2116 North Tejon Street

This application proposes a 320 square feet deck addition on the rear of the existing residence.

HIST-24-0008

Report of Acceptability

Existing rear landing

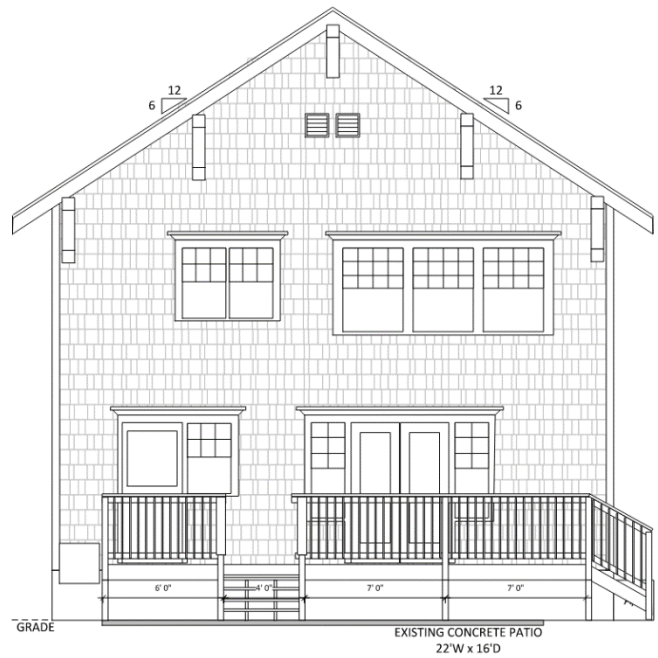
The proposed deck is being constructed in approximately the same location as a previously constructed deck (aka rear landing). The photo below shows the existing landing.
